**UTAH DIVISION OF RADIATION CONTROL
ENERGYSOLUTIONS CLIVE LLRW DISPOSAL FACILITY
LICENSE NO: UT2300249; RML #UT 2300249**

**CONDITION 35 COMPLIANCE REPORT; APPENDIX A:
FINAL REPORT FOR THE CLIVE DU PA MODEL**

**SAFETY EVALUATION REPORT
VOLUME 1**

April 2015

Figure 4-4 – Comparison of redox coupled and uncoupled solubility models

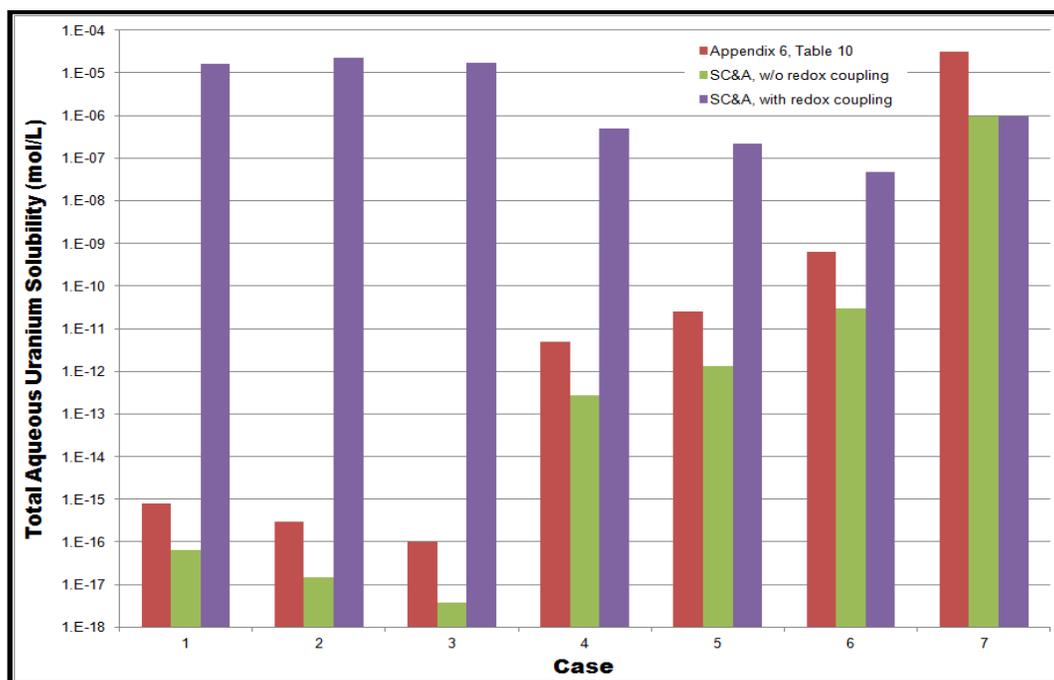
In EnergySolutions’ response to Round 1 interrogatories (ES 2014d), the last line of Table 2-64/1 presents uranium solubility data from SNL 2007. **The uranium concentrations reported in EnergySolutions’ Table 2-64/1 seem to only include the solubility of hexavalent-state uranium [U(VI)] and mixed U(IV/VI) phases and do not consider the potential formation of U(IV) phases [i.e., aqueous U(IV)(OH)_x^{4-x} species and U(IV) minerals such as uraninite]. Formation of uraninite will significantly decrease overall uranium solubility in groundwater.** As noted in the Round 2 Interrogatory CR R313-25-8(4)(a)-64/2 (DRC 2014b), the DU PA **needed to clarify clarified** whether the geochemical model considers the potential formation of uraninite or other U(IV) phases and the expected redox conditions of the waste in the landfill, because not considering the U(IV) phases if they are indeed forming will result in an overly conservatively high estimate of aqueous uranium concentrations, due to failure to consider aqueous uranium hydroxide [U(OH)₄].

running the model. It appears that the intent of the modeling exercises examining schoepite¹¹ and U₃O₈ solubility in Tables 9 through 12 of the geochemical modeling report (Neptune 2014m) was to give the boundaries of uranium solubility. However, it is unrealistic to run a model with a relatively high E_H/pH condition (such as pH 8, E_H 200 millivolts in Table 10) and not allow for the oxidation of reduced species. Therefore, the Round 2 Interrogatory CR-R313-25-8(4)(a)-64/2 expressed a concern about whether the reported low solubility values in EnergySolutions Table 12 are reliable for use as the source term in reactive transport models. Figure 4-4 and Table 4-2 show the reported values from EnergySolutions Table 12 as well as two columns of output from additional DEQ Visual MINTEQ runs. As part of the DU-PA review, DEQ used the average ion concentrations in the last row of Table 8 in conjunction with the data in Table 12 of the geochemical modeling report (Neptune 2014m) in an attempt to reproduce the reported total dissolved uranium concentrations shown in Table 12. This was done by running the model with the U(IV)/U(VI) system uncoupled, as was apparently done for the model output shown in Table 12. However, the final column in Table 4-2 shows the total uranium concentration in a Visual MINTEQ model with the U(IV)/U(VI) reaction coupled. Oxidation of U(IV) to U(VI) is therefore allowed, and the expected total dissolved uranium concentrations are significantly higher. Because the redox chemistry of the waste disposal site in this work is variable, DEQ recommended in the Round 2 interrogatory CR-R313-25-8(4)(a)-64/2 (DRC 2014b) that redox-coupled solubility calculations be used when defining the source concentrations in reactive transport models. The specific E_H and pH ranges expected under the various geologic conditions considered in the reactive transport models must be used in this source term analysis.

Figure 4-5— Mean radon flux in the embankment

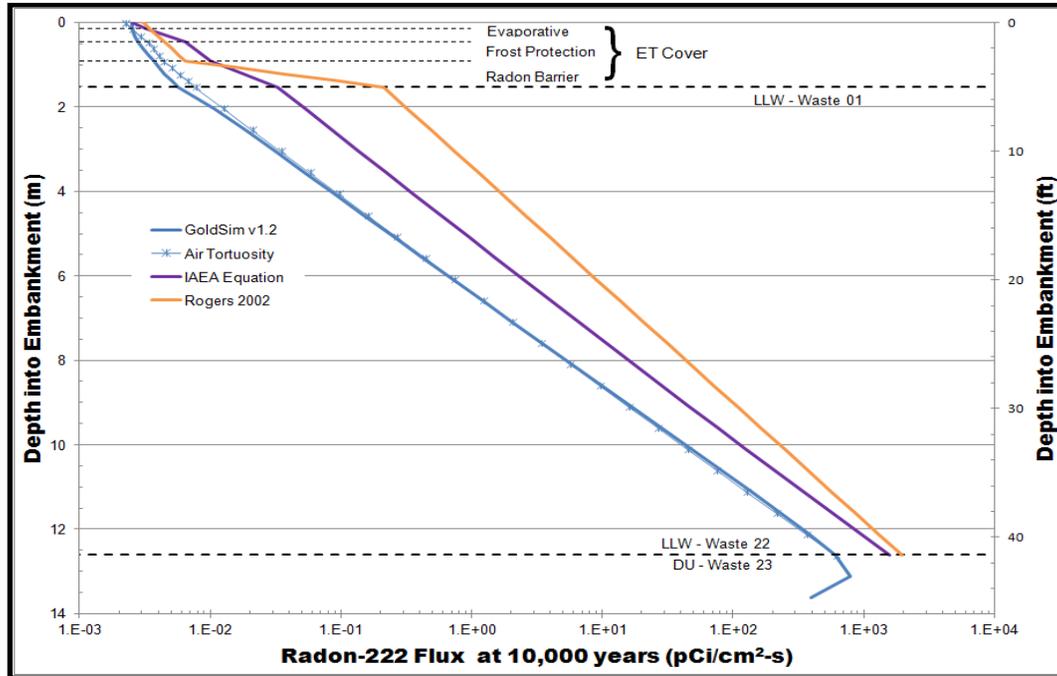
The first thing to notice about Figure 4-5 is that all of the calculated ground surface fluxes are about the same, as shown in Table 4-4 (column 2).

Second, there is a large difference between the GoldSim v1.2 radon attenuation in the ET cover and the ET cover attenuation calculated by either the IAEA Equation or Rogers 2002. For both the IAEA Equation and Rogers 2002, the attenuation provided by the radon barrier layers is clearly shown in Figure 4-5, but for the GoldSim v1.2 there is virtually no attenuation by the radon barrier layers [Table 4-4 shows only an attenuation of 2.3 (i.e., 0.0057 picocuries per

square meter per second [$\text{pCi}/\text{m}^2\text{-s}$] \div 0.0025 $\text{pCi}/\text{m}^2\text{-s}$) for GoldSim v1.2]. In fact, close examination of the Figure 4-5 GoldSim v1.2 curve shows that there is less attenuation per unit thickness in the radon layers than there is in the waste layers. This is due to the different correction factors that EnergySolutions/Neptune calculated and applied (i.e., 0.394 for the waste layers and 0.894 for the radon barrier layers) and Equation (4)'s linear relationship between moisture content and diffusion coefficient. In other words, the increase in the correction factor more than compensated for the increase in the moisture content.

The Air Tortuosity curve in Figure 4-5 agrees well with the GoldSim v1.2 radon flux, indicating that GoldSim v1.2 is performing the calculations as described in the Clive DU PA Model v1.2 documentation (Neptune 2014j).

Figure 4-7 Ingestion dose at 10,000 years versus infiltration rate

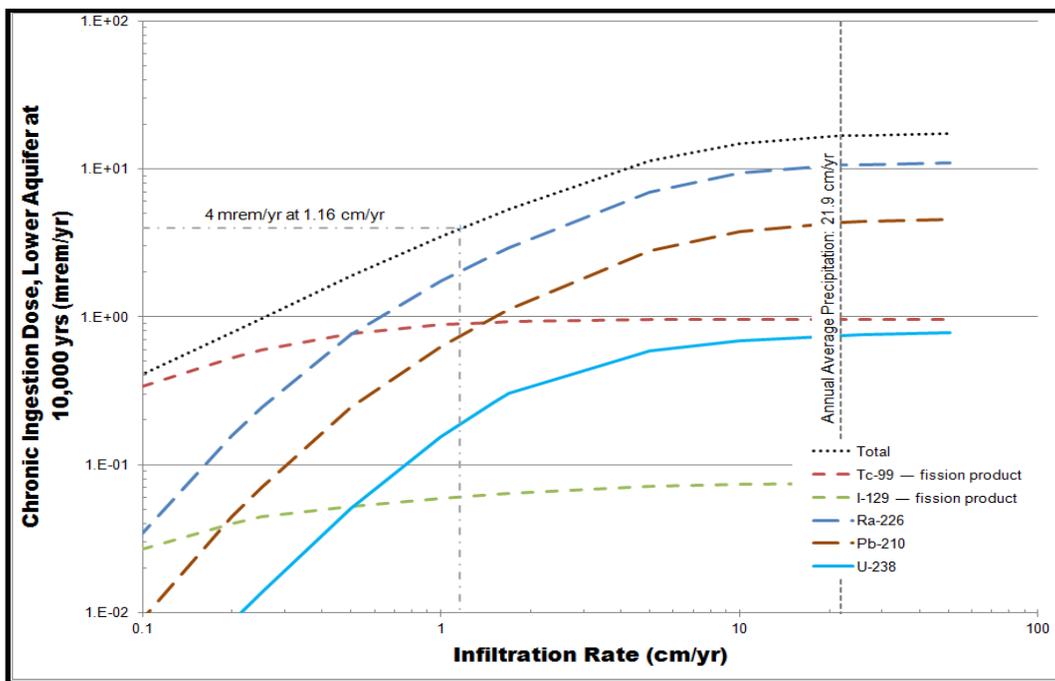
To provide additional perspective on the significance of the groundwater ingestion pathway, DEQ performed a bounding calculation in which it was assumed that the yield from the upper aquifer was sufficient to provide enough water to support a household. As discussed above, this scenario is bounding because the yield from the upper aquifer is not sufficient to support such a scenario. This calculation, which is summarized in Table 3 of Marschke (2015), shows that for time periods up to 10,000 years, a 1:11 dilution of upper to lower aquifer water is necessary to reduce the calculated dose to below the UAC R313-25-19 dose from groundwater limit of 4 mrem/yr. However, if disposal of DU-containing recycled uranium is not permitted as proposed in this SER, then the bounding undiluted upper aquifer groundwater ingestion dose is 1.4 mrem/yr, which is below the UAC limit.

As discussed below in Section 4.4.1, there is much uncertainty regarding the infiltration rate that was utilized in DU PA v1.2. Figure 4-7 shows how the calculated chronic groundwater ingestion dose would vary as a function of the infiltration rate, with all other parameters remaining the same as for the Table 4-5 and Figure 4-6 doses. When viewing Figure 4-7, keep in mind that the mean infiltration rate used in DU PA v1.2 was 0.0344 cm/yr (see Section B.7, page B-11). Figure 4-7 shows that, if the infiltration rate exceeds 1.16 cm/yr, the chronic groundwater ingestion dose from this exposure pathway would exceed the UAC R313-25-19 groundwater exposure dose limit of 4 mrem/yr.

Figure 4-9—Correlation of saturated hydraulic conductivity and van Genuchten alpha

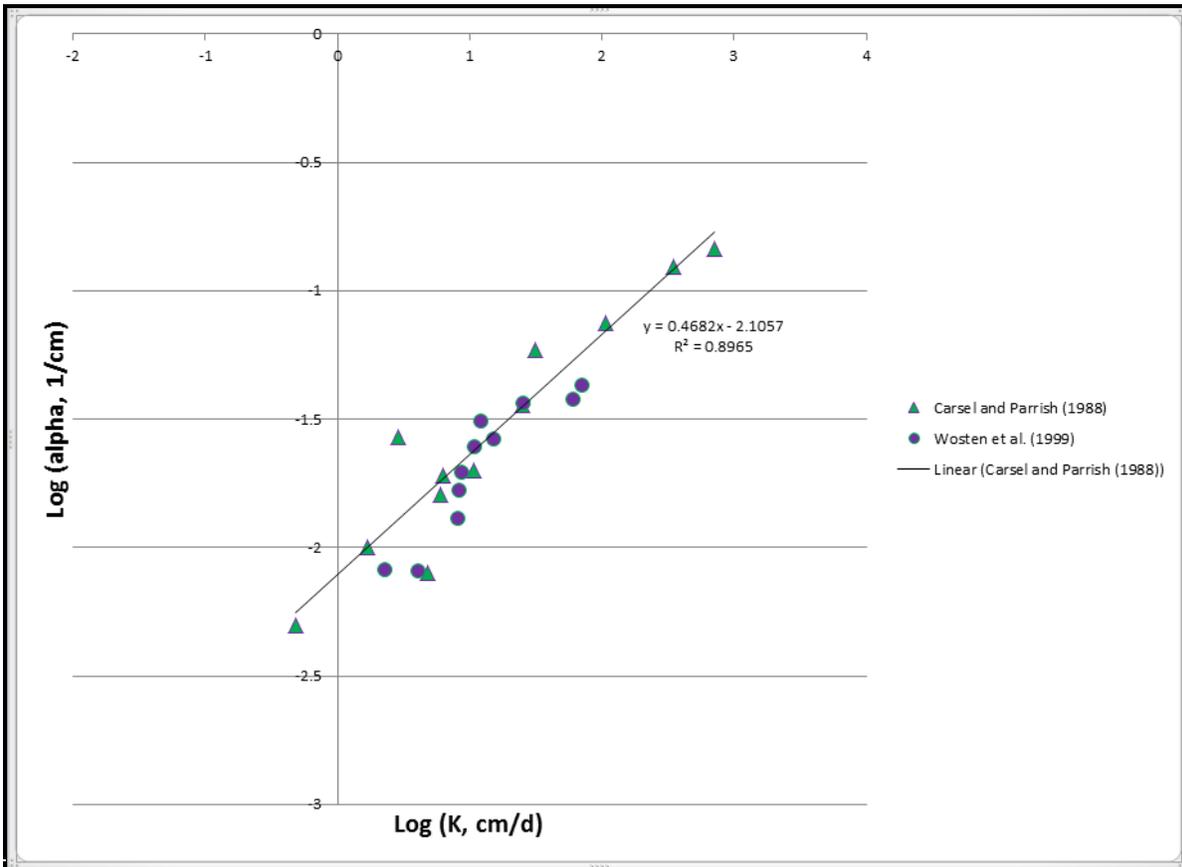
Carsel and Parrish (1988) grouped a soil data set of 5,093 samples with reported K_{sat} (shown as “ K_s ” in Figure 4-9) and α values into 12 U.S. Department of Agriculture soil textural classifications (e.g., sandy loam). This is the largest North American database dedicated to hydraulic properties of soils. In Figure 4-9, DEQ has plotted K_{sat} versus α for each of the 12 soil textural classifications. A regression of the data indicates a very strong correlation ($R^2 = 0.8965$) between $\log(\alpha)$ versus $\log(K_{sat})$. Wösten et al. (1999) collected data from 20 institutions of higher learning in 12 European countries to develop the database HYPRES (Hydraulic Properties of European Soils). This is the largest European database dealing with hydraulic properties of soils. Wösten et al. (1999) grouped their data into 11 soil textural classifications, each with reported K_{sat} and α values. As shown in Figure 4-9, these data exhibit some variability but generally fall in a similar range to the Carsel and Parrish (1988) data.

A Google search indicates that the Carsel and Parrish (1988) publication has been cited by 1,198 other articles that are peer reviewed. Statistical data based on Carsel and Parrish (1988) are included in NUREG/CR-6565 (Meyer et al. 1997), NUREG/CR-6656 (NRC 1999), and NUREG/CR-6695 (NRC 2001). DEQ developed the regression equation in Figure 4-9 [$\log(\alpha) = 0.4682 \times \log(K_{sat}) - 2.1057$] based solely on the Carsel and Parrish (1988) data. The NUREG/CR-6346 (NRC 1996) data are for one site described in this NRC guidance document. It is interesting to note that an equation for a linear regression for the NUREG/CR-6346 (NRC 1996) data is very similar—almost identical—to that developed for the Carsel and Parrish (1988) data.

Given these data sets in the professional literature, it is not clear that EnergySolutions has used appropriate data for the saturated hydraulic conductivity or reflected the correlation between $\log(\alpha)$ and $\log(K_{sat})$ or between α and K_{sat} . In its response to Round 3 Interrogatory CR R313-25-7(2)-189/3: Modeling Impacts of Changes in Federal Cell Cover System Soil Hydraulic Conductivity and Alpha Values (ES-2014b), EnergySolutions stated that there was no correlation found between K_{sat} and α . It plotted the Rosetta database (Schaap 2002) values on a plot similar to Figure 4-9 and stated that there was no correlation. The Carsel and Parrish (1988) database is a much larger database (about an order of magnitude larger than the Rosetta database). The Wösten et al. (1999) database is also quite large. Furthermore, an equation exists for the relationship between α and K_{sat} based on soil physics that can be readily shown to be transformable to $\log(\alpha) = 0.5 \times \log(K_{sat}) - 2.14$, which is nearly identical to the correlation equation for the Carsel and Parrish (1988) data (Guarracino 2007). Meyer et al. (1997) and Zhu et al. (2007) have also described correlation between $\log(\alpha)$ and $\log(K_{sat})$ or between α and K_{sat} . Given the apparent differences in the Rosetta database and that of Carsel and Parrish (1988) and others regarding whether or not correlation exists between α and K_{sat} , it would seem that a comparative analysis should be undertaken.

Figure 5-1 – Mean radon flux above depleted uranium

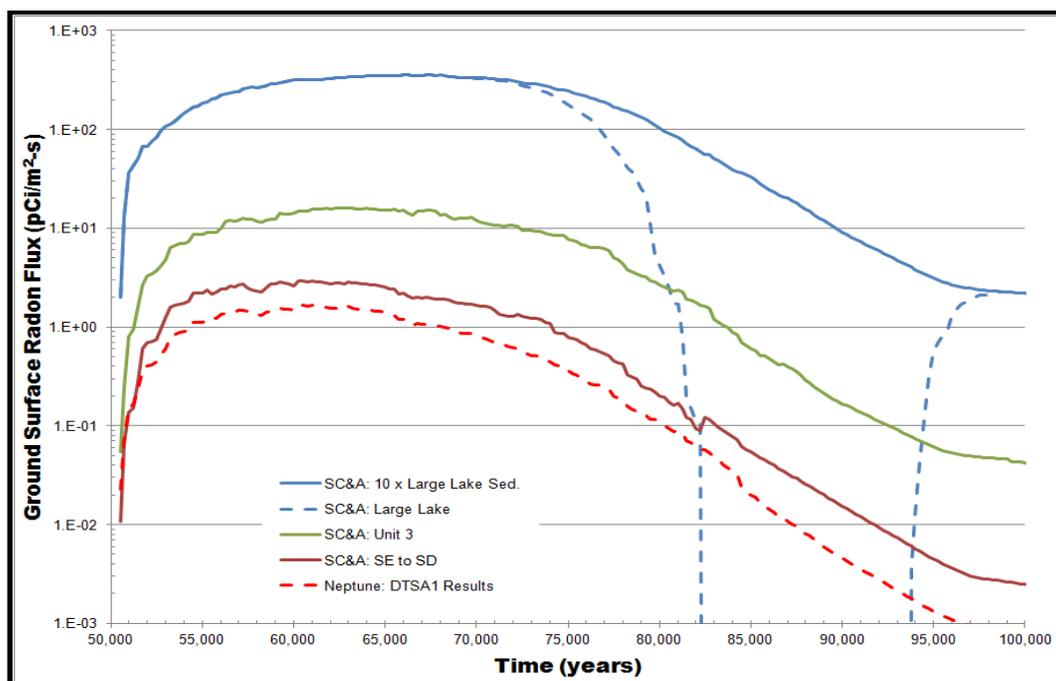
Detailed descriptions of each of the five SC&A GoldSim cases are provided below, while Figure 5-1 shows the time-dependent ground surface radon fluxes for the GoldSim deep time runs that were made by SC&A, and **Table 5-1** provides the peak mean flux for each run.

The Figure 5-1 dashed blue curve (SC&A: Large Lake) is the same as the SC&A: 10x Large Lake case (the solid blue curve) except that ground surface radon flux has been set to zero whenever a Large Lake is present. Because their durations are about the same length as the time step used in the GoldSim model, it was not feasible to set the radon flux to zero during the presence of an Intermediate Lake. Since the peak mean radon flux occurs following the first Intermediate Lake, setting the flux to zero during the presence of a Large Lake has no impact on the peak mean radon flux, as shown by Figure 5-1.

Figure 5-3 – Comparison of standard error to standard deviation

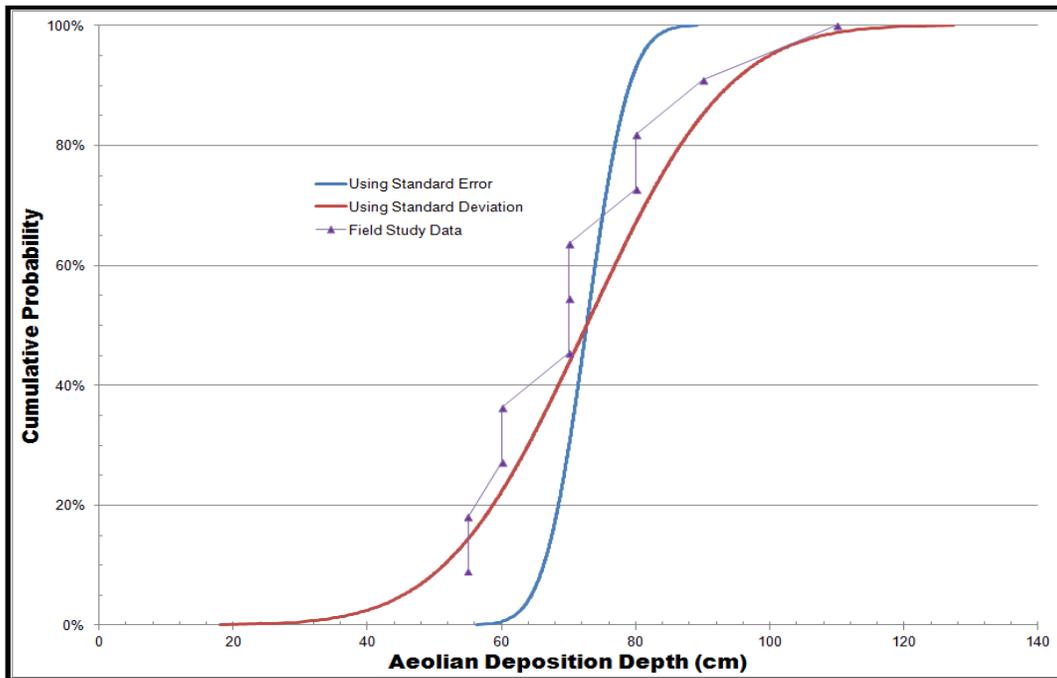
Figure 5-3 shows the impact that using the standard error instead of the standard deviation would have on the aeolian deposition depth. For comparison purposes, Figure 5-3 also shows the distribution of the 11 depths (i.e., silt thicknesses) that were obtained from the field studies (Neptune 2015b, Table 2). When compared to the standard deviation, the standard error of the mean tends to remove the extremes from the analysis. If the measurements were of annual deposition rates, where there is expected to be a wide variation from year to year, then the use of the standard error of the mean would be appropriate. However, the measurements that were taken are of the total sedimentation depth accumulated over thousands of years, which accounts for any year to year fluctuation in the sedimentation rate. Thus, the use of the standard deviation is believed to be appropriate.

Figure 5-3 shows that the “tails” of the standard error distribution are much shorter than the “tails” of the standard distribution. In fact, the aeolian deposition depth calculated from the standard error distribution never reaches the maximum depth of 110 cm that was measured in the field studies. It is believed that the Figure 5-3 standard deviation curve is a much better match to the field study data than the Figure 5-3 standard error curve.

Figure 5-9— DEQ-calculated fraction of GWPL for various radionuclides as a function of time based on all DU PA inventory at the 90-foot well (unconfined aquifer)

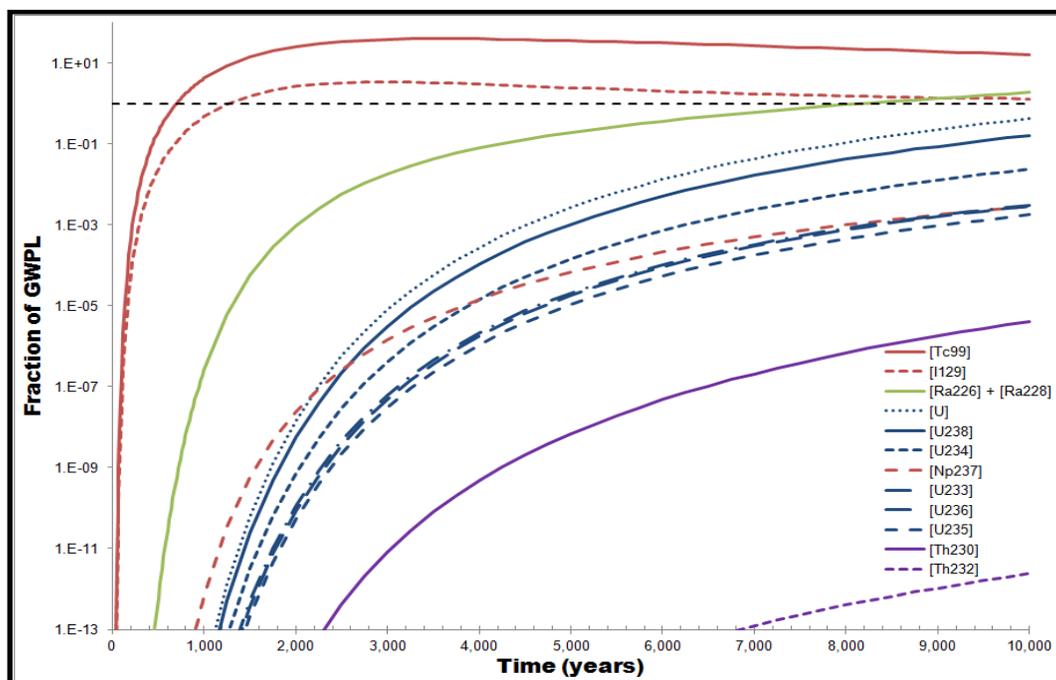
Figure 5-9 shows the fraction of the GWPL for various radionuclides as a function of time (based on 1,000 iterations with GoldSim Model v1.2 as determined by DEQ). The fractions of GWPL values in Figure 5-9 are obtained by dividing the well concentrations for each radionuclide obtained from the GoldSim model v1.2 by the GWPLs from Table 5-10. For this simulation, all of the DU waste inventory was included. It can be seen that Te-99, I-129, and Ra-226 exceed the GWPLs at the 90-foot shallow well at some point in time within the 10,000-year simulation period. This simulation is simply an extension of all inputs and assumptions used by EnergySolutions for its 500-year GWQ Permit evaluation period analysis.

Even though Figure 5-9 shows that after the 500-year GWQ Permit evaluation period some of the GWPLs are exceeded, the groundwater ingestion analysis discussed in Section 4.2.2 indicated that the UAC Rule R313-25-20 groundwater pathway dose limit of 4 mrem/yr is not exceeded.

Figure B-1—GoldSim versus HYDRUS infiltration flux

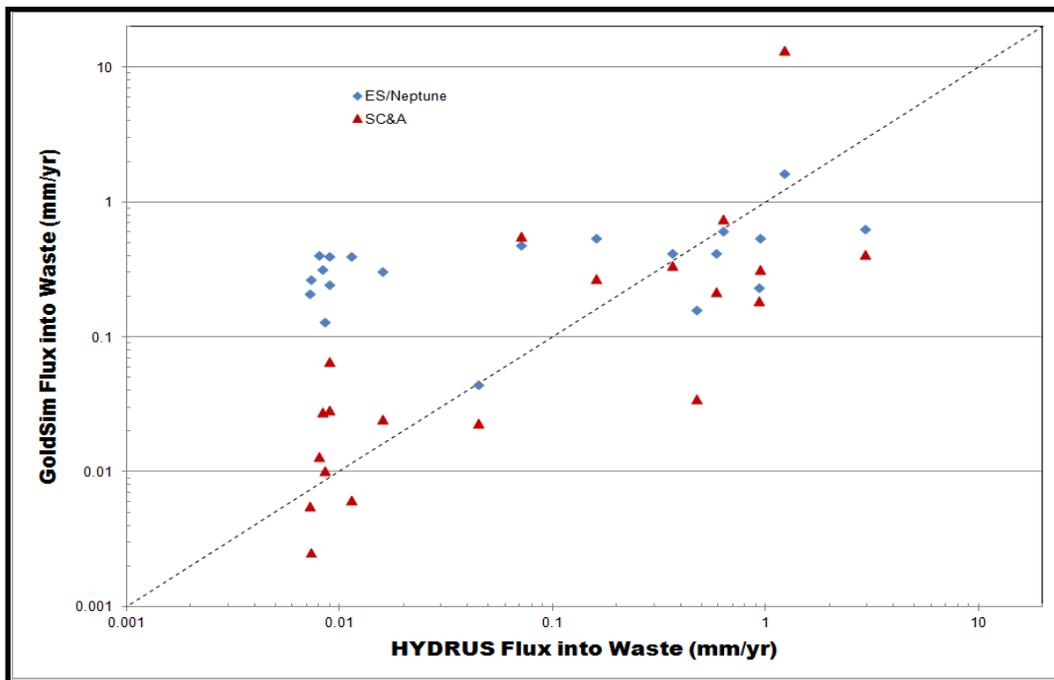
As an alternative to the linear regression, DEQ/SC&A fit an exponential equation to the van Genuchten α , n , and K_{sat} input data and the HYDRUS calculated fluxes (Figure B-1). The triangles shown in Figure B-1 are the fluxes calculated using the following exponential fit: $Flux = 45.465 \times \alpha^{1.4408} \times n^{-1.332} \times K_{sat}^{-0.445}$. For large fluxes, the exponential fit does not appear to be much better than the linear fit, but for small fluxes (which tend to result when the van Genuchten α is small), the exponential fit is much better than the linear fit.

1) The linear regression equation that has been programmed into GoldSim does not give results that are consistent with what is calculated by HYDRUS (i.e., for a given pair of α and n , the regression equation result in GoldSim does not approximate the HYDRUS result). This is demonstrated by Figure B-1 (See DEQ Critique to Supplemental Interrogatory Comment 5).
